The Sizewell C Project

Consultation Document

Consultation on Further Proposed Project Changes

Figure 2.2: Proposed change to the alignment of Bridleway 19

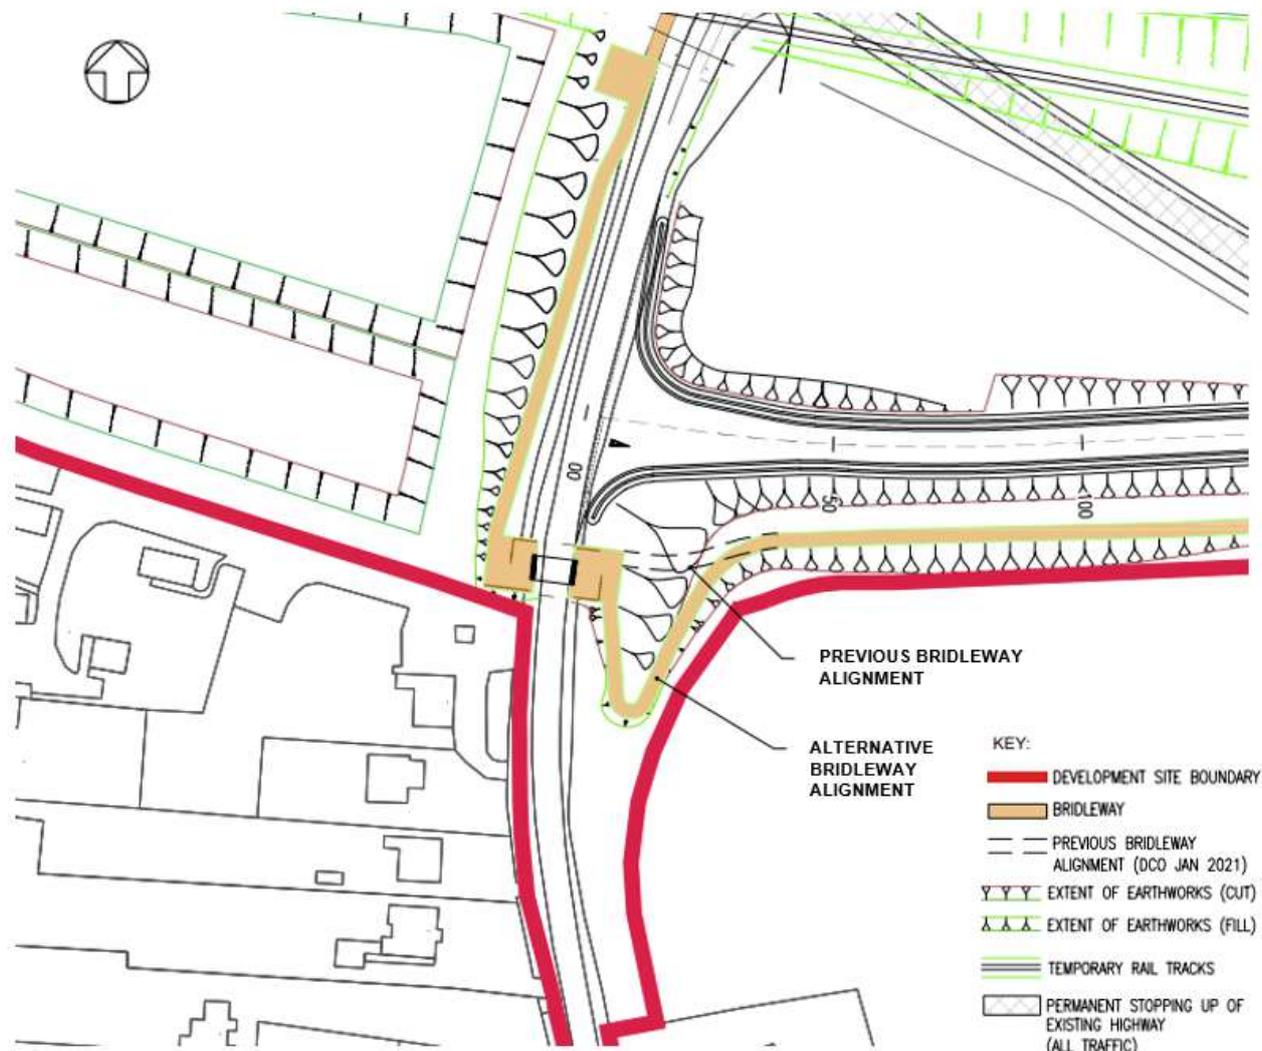
2.2.1. SZC Co. proposes to change the alignment of Bridleway 19, south of the B1122 (Abbey Road)/Lover’s Lane junction, from a straight east-west alignment to an alignment with a small, kinked diversion to the south. This minor diversion to the south would allow for a less steep gradient for equestrian use (refer to Figure 2.2).

2.2.2. SZC Co. also proposes to relocate the Pegasus crossing on Lover’s Lane 10m to the south (refer to Figure 2.3). This would improve visibility for users of the Pegasus crossing and vehicular traffic on Lover’s Lane, including vehicles exiting the existing Recycling Centre in a southerly direction. It would also maintain appropriate visibility splays in compliance with DMRB standards and Bridleway Design Guidelines².

Figure 2.3: Proposed change to the Pegasus crossing and mammal culvert

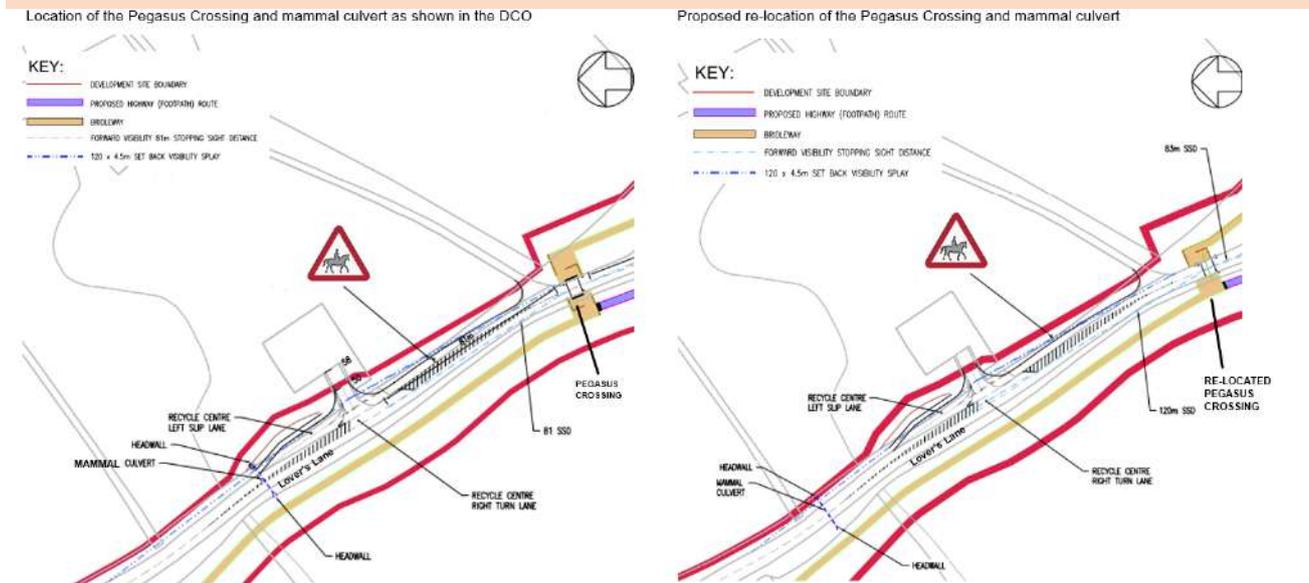
2.2.8. SZC Co. proposes to re-position the mammal culvert (refer to Figure 2.3), which passes under Lover's Lane, so that it is closer to the Leiston Drain watercourse, providing improved connectivity. The re-positioned culvert would make the crossing more attractive and effective for mammals to use and fencing is proposed to guide mammals to the crossing. The level of the mammal crossing would take account of the flood modelling in the Leiston Drain area.

Figure 2.4: Proposed removal of trees from the tree belt adjacent to Bridleway 19

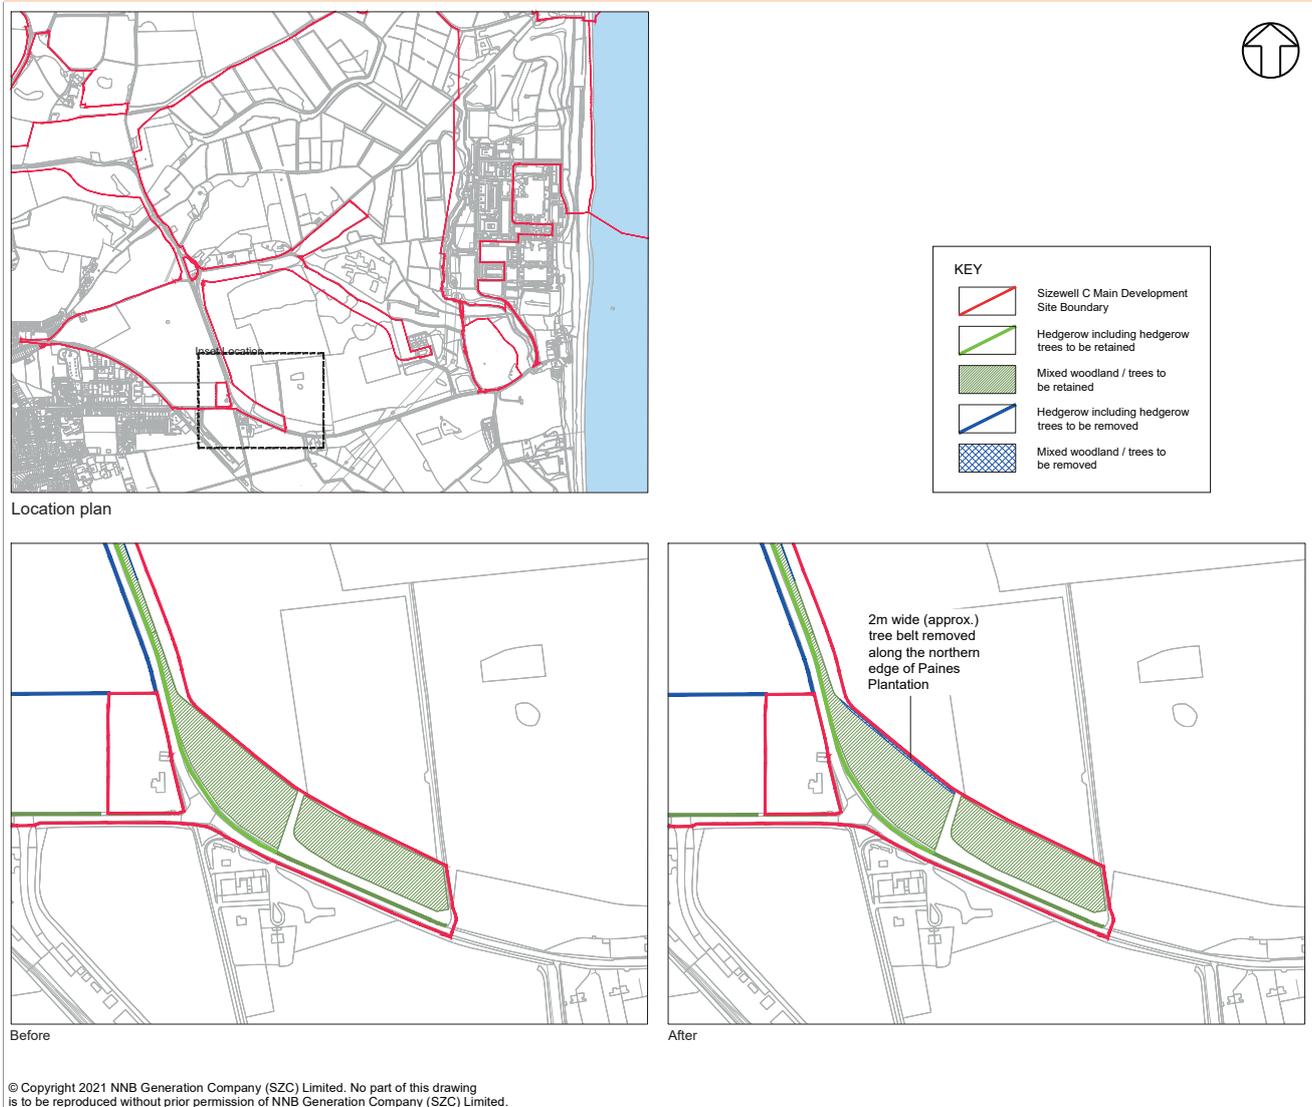
2.2.4. In the DCO Application the alignment of Bridleway 19 passes along the whole northern edge of Paines Plantation, but further design development has identified that this alignment would require the removal of a strip of trees measuring approximately 150m in length to allow the Bridleway to have the necessary width to comply with Bridleway Design Guidelines. The current width of Paines Plantation varies, but the majority is between 40–60m wide.

2.2.5. SZC Co. proposes to change the alignment of Bridleway 19 to pass along the south of Paines Plantation, and then pass through an existing gap in the woodland of Paines Plantation, before continuing along the northern edge of Paines Plantation (refer to Figure 2.4)³.

2.2.6. This change will minimise tree loss, as Bridleway 19 will only pass along the northern edge of Paines Plantation, where the existing trees are located, for approximately 150m. This change is likely to require the removal of approximately 30–40 trees.

Figure 3.1: Illustrative masterplan of the two village bypass (western section)

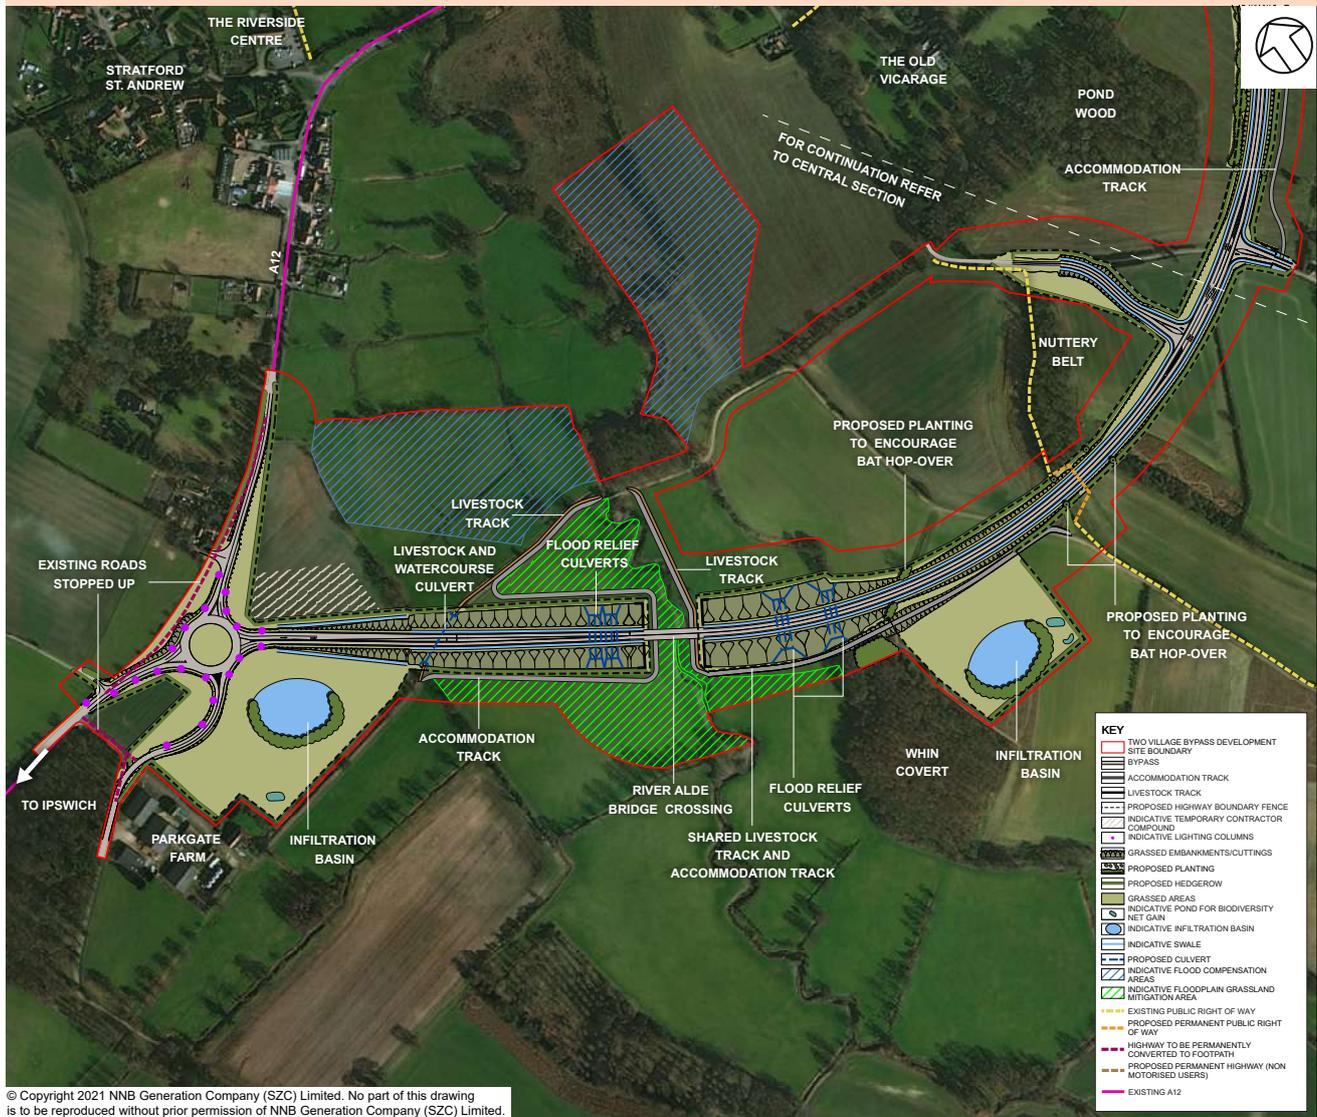
3.2.1. Following continued engagement with the EA, ESC and SCC, SZC Co. proposes to reduce the length of the flood relief culverts through the River Alde overbridge embankment from 70m to 50m to meet the EA's requirements for culvert length (refer to Figure 3.1). A 50m length culvert is the upper limit of culvert length preferred by the EA to reduce the risk of blockages, to ease maintenance and to maximise the chances of it being used by otters.

3.2.2. To allow for the shorter culverts, the gradient of the accommodation track, which is used for livestock and farm vehicles, located just south of the two village bypass route, is proposed to be amended to have a 10% gradient (refer to Figure 3.1).

Figure 3.2: Proposed removal of brideway upgrade and reduction in Order limits

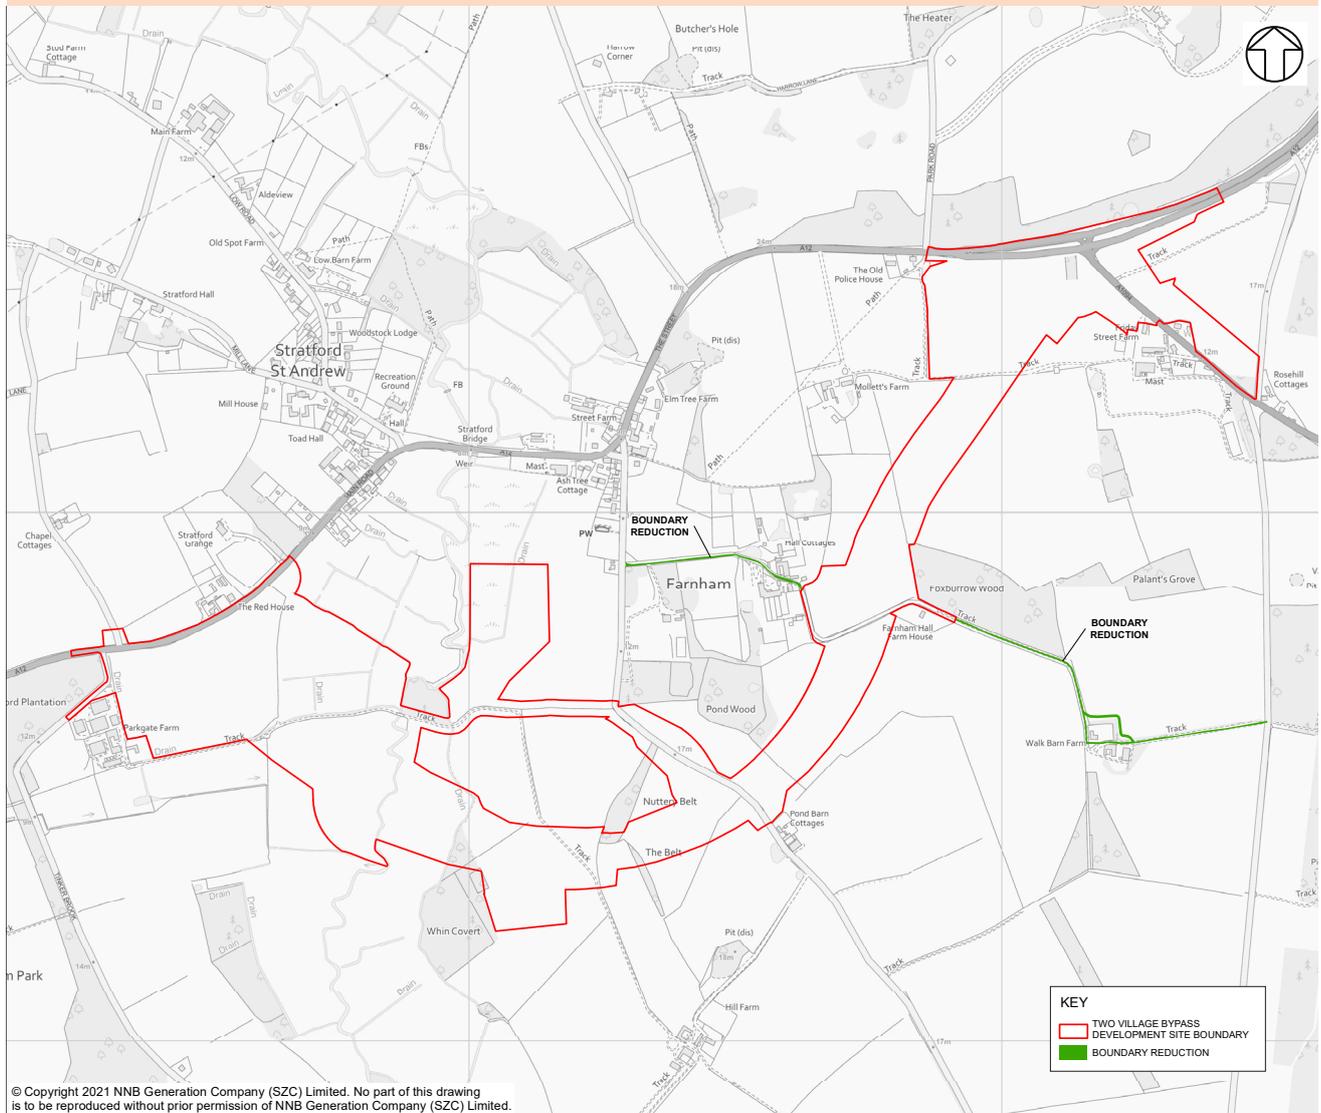
3.2.5. However, further analysis by SZC Co. has shown that the bridleway upgrade is not required to mitigate the impacts of the two village bypass. Therefore, it would not be justified to seek compulsory acquisition powers over this land or for it to be included within the Order limits. This change is also proposed as a result of consultation feedback from affected landowners.

3.2.6. SZC Co. proposes to remove the bridleway upgrade from the Application. This change would result in a reduction in the Order limits, as indicated in Figure 3.2

Figure 3.3: Illustrative masterplan of the two village bypass (eastern section)

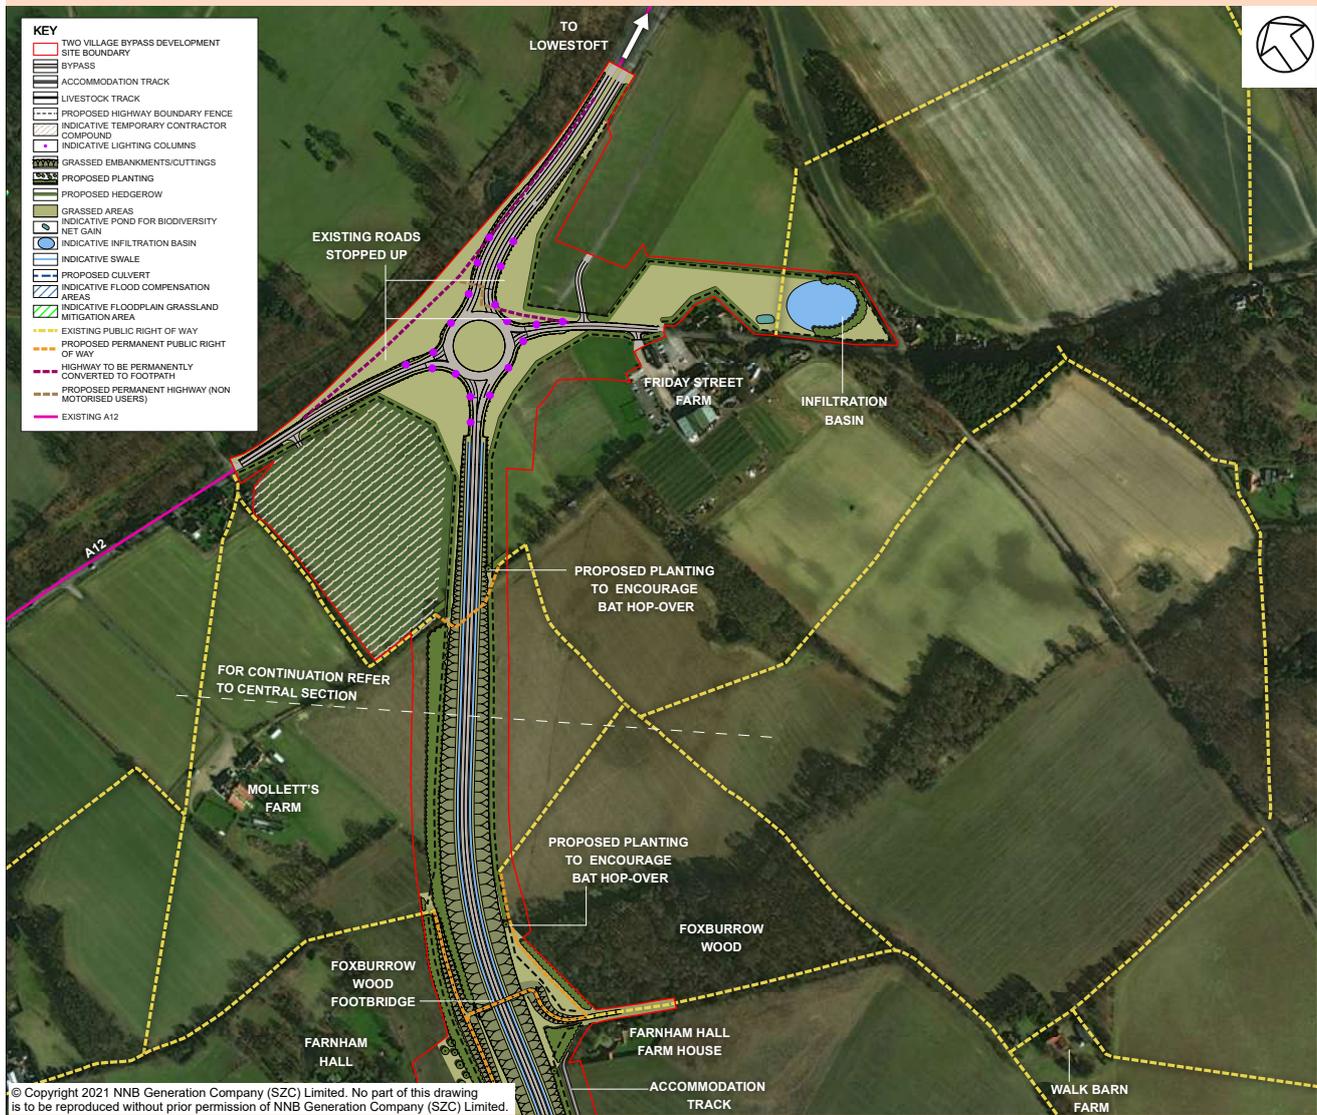
3.2.7. SZC Co. proposes to create a crossing across the north-eastern arm of the proposed Friday Street roundabout (across the tie-ins with the existing A12 towards Saxmundham). The proposed crossing would provide a link for Non-Motorised User use (i.e. pedestrians, cyclists, equestrians) between the 'old' A12 and the 'old' A1094. This is indicated in Figure 3.3.

3.2.8. The proposed crossing would allow for pedestrian, cycle and equestrian access between the proposed Non-Motorised User routes and provide safe access between Farnham and Friday Street Farm by foot or bicycle. It would also assist in pedestrian and cyclists travelling to/from Farnham connecting with footpath E-137/028/0 off the A1094.

Figure 4.3: Proposed amendments to the Order limits (west of the East Suffolk line and Middleton Moor Roundabout)

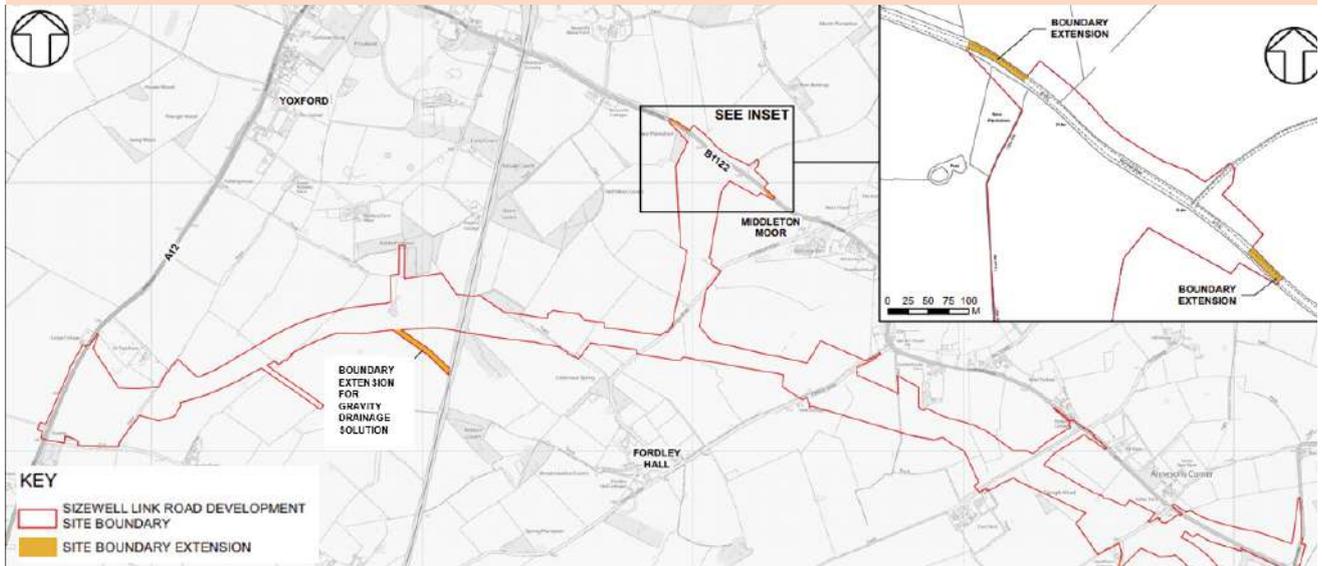
4.2.9. SZC Co. proposes to extend the Order Limits to allow for a gravity drainage solution (rather than a pumped solution) to be achieved in this location (refer to **Figure 4.3**).

4.2.20. Small increases to the Order limits in this location are proposed, as indicated in **Figure 4.3**. This is to allow for an improved tie in between the eastern and western arms of the proposed Middleton Moor roundabout and the existing B1122. This extension would involve highway land only over which no compulsory acquisition powers would be required.

Figure 4.4: Proposed amendments to the limits of deviation (near Brown's Plantation, Moat Road Junction and Eastern end of Sizewell link road)

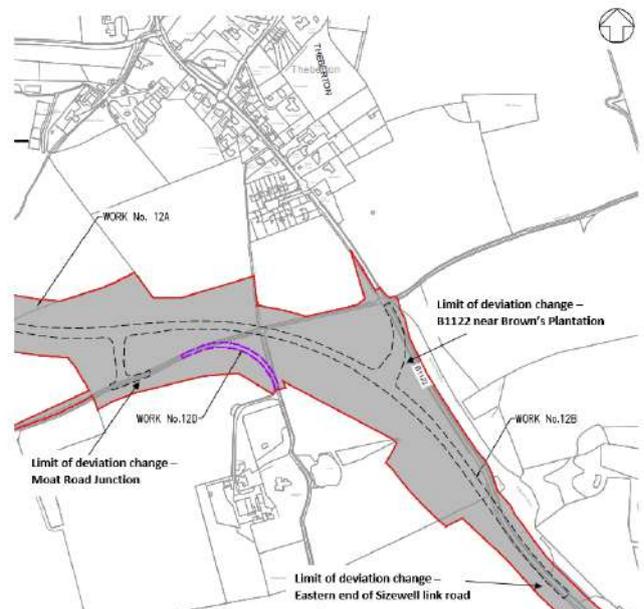
4.2.10. SZC Co. proposes a minor change to the alignment of the road layout where the Sizewell link road joins the B1122 near Brown's Plantation. This change is as a result of progressing the design of the Sizewell link road through engagement with SCC and would avoid the need to depart from the DMRB safety standards.

4.2.11. This change is minor. It would result in an amendment to the dashed limit of deviation line shown on Works Plan SZC-SZ0204-XX-000-DRW-100484 Rev 03 [Examination Library Ref. [AS-286](#)] (refer to **Figure 4.4**) but there would be no extension of the Order limits required.

- Trust Farm Link/B1122 junction (refer to **Figure 4.5**);
- Moat Road junction (refer to **Figure 4.4**); and
- Eastern end of the Sizewell link road where it joins the existing B1122 (refer to **Figure 4.4**).
